Re: Comments on the Proposed Desired Future Conditions/Modeled Available Groundwater (DFC/MAG) Scenario 26-17

R. W. Harden & Associates, Inc. (RWH&A) has performed an evaluation of model Scenario 26-17 that was adopted by GMA-13 in April 2026, which is to be used in the development of new DFCs. Scenario 26-17 is comprised of a MODFLOW pumpage input file that is incorporated in the newly adopted Southern Carrizo-Wilcox-Queen City, Sparta Groundwater Availability (GAM) to predict aquifer responses through 2080.

Plate 1. Simulated Carrizo (Layer 7) Outcrop Dry Cells and Saturated Thickness Declines

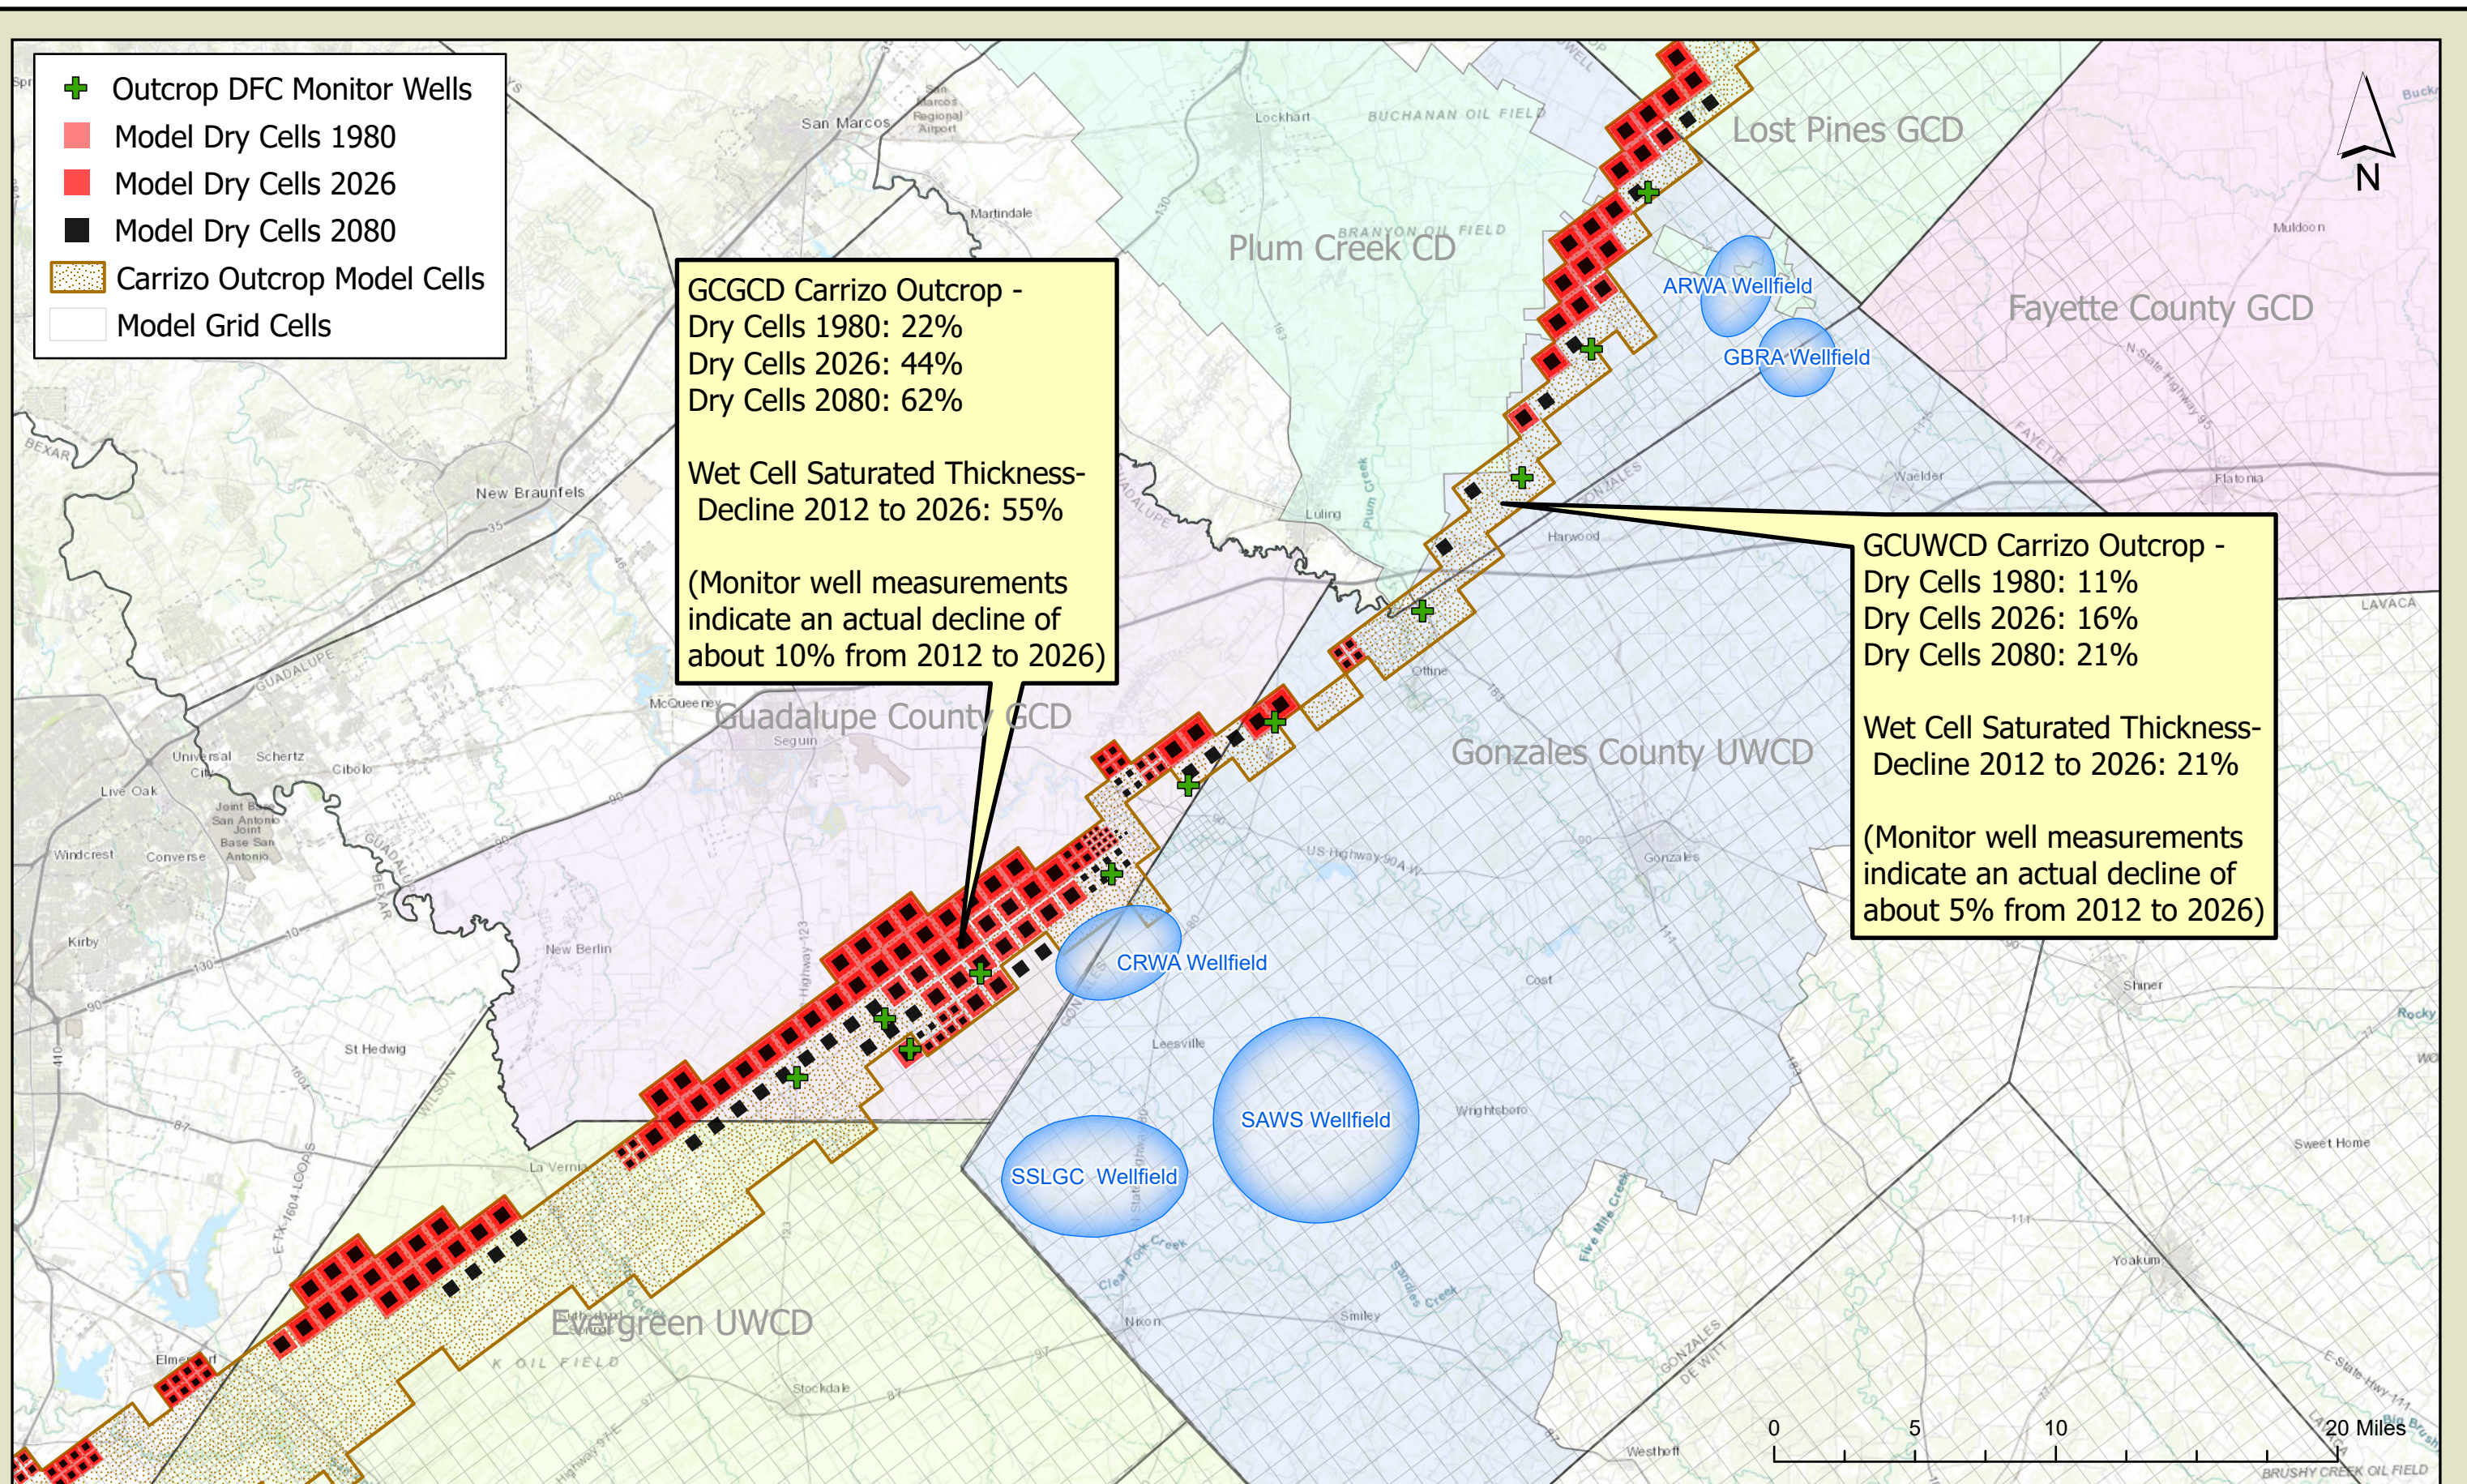
Comparison of measured water levels with outputs from the recently adopted GAM indicates that the model performs poorly in aquifer outcrop areas located near significant pumpage centers. Specifically, inaccurate GAM predictions were noted in the outcrop near the ARWA, CRWA, and GBRA well fields. In those areas, the GAM shows widespread "dry" model cells where simulated water levels are below the bottom of the cells, while water level monitoring, conducted by both the GCUWCD and the GCGCD, indicates that the aquifer is saturated and has undergone relatively small declines over the last decade. Plate 1 shows the distribution of simulated dry cells at the beginning of the simulation (1980), current conditions (2026), and the end of the simulation (2080). The GCGCD Carrizo outcrop shows the greatest proportion of simulated dry cells, with dry conditions in approximately 22% of outcrop cells in 1980, 44% in 2026, and 62% in 2080. Similarly, simulated dry cells are widespread in the Carrizo outcrop in the northernmost portion of the GAM near the ARWA/GBRA well field area.

The current DFC limits allowable outcrop saturated thickness declines to a maximum of 25% in the interval between 2012 and 2080. In the GCGCD, the GAM results suggest that the saturated thickness decline between 2012 and 2026 of about 55%, while measurements from dedicated DFC monitoring sites indicate that the average decline over the past 13 years was approximately 10%. Stated another way, the GAM inaccurately simulates more than five times more drawdown than was observed in the GCGCD outcrop since 2012 and predicts that the DFC limits were surpassed several years ago.

Plate 2. Measured versus Simulated Carrizo Outcrop Water Levels (Southwest Section)

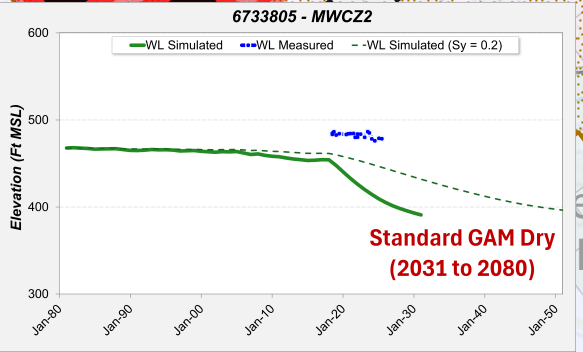
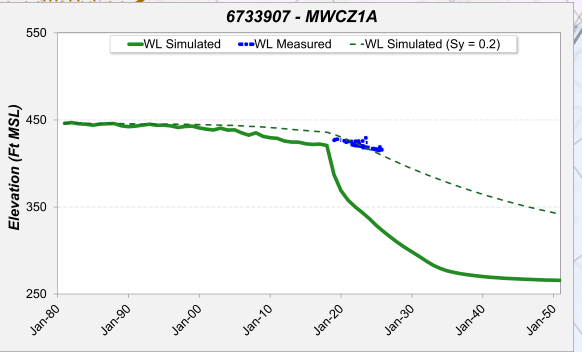
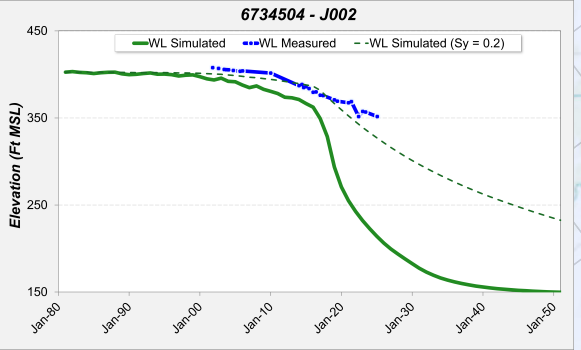
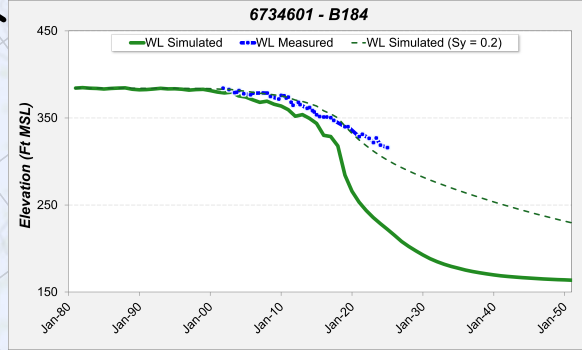
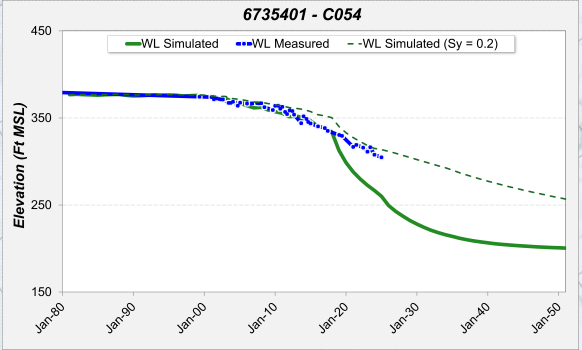
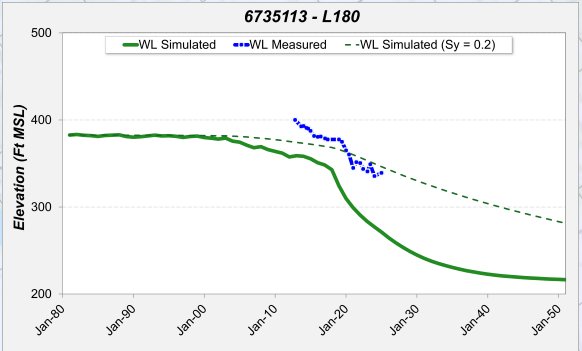
In addition to simulated dry cells in areas known to be saturated, the GAM significantly overpredicts the water level declines (drawdown) near pumpage centers such as the CRWA well field, which straddles the Gonzales/Guadalupe county line southeast of Seguin, Texas. Plates 2 and 3 show hydrographs of measured and simulated water levels at sites monitored by the GCUWCD and the GCGCD. The blue points/lines plot the measured water level elevations at each monitoring site, while the heavy green line shows the water levels output from the current GAM with Scenario 26-17

pumpage, while the dashed green line shows the results of an additional simulation discussed below. At most sites, the simulated drawdown is significantly greater than measured drawdown. The greatest overprediction of drawdown occurs near the CRWA well field, with up to approximately 150 feet of excess simulated drawdown occurring at sites shown on Plate 2.

In order to provide perspective regarding the impact of specific yield on model accuracy, an alternate version of the GAM was generated for this evaluation that was identical to the adopted GAM (with Scenario 26-17 pumpage) except that a constant specific yield value of 0.2 was applied to the model layer representing the Carrizo (Layer 7). The results of this alternative GAM are plotted on the Plates 2 and 3 hydrographs as thinner, green, dashed lines labeled “WL Simulated (Sy = 0.2)”. As shown, application of the increased specific yield values resulted in much stronger agreement between simulated and measured outcrop decline rates in areas near pumpage centers and a reduction in the occurrence of dry cells.
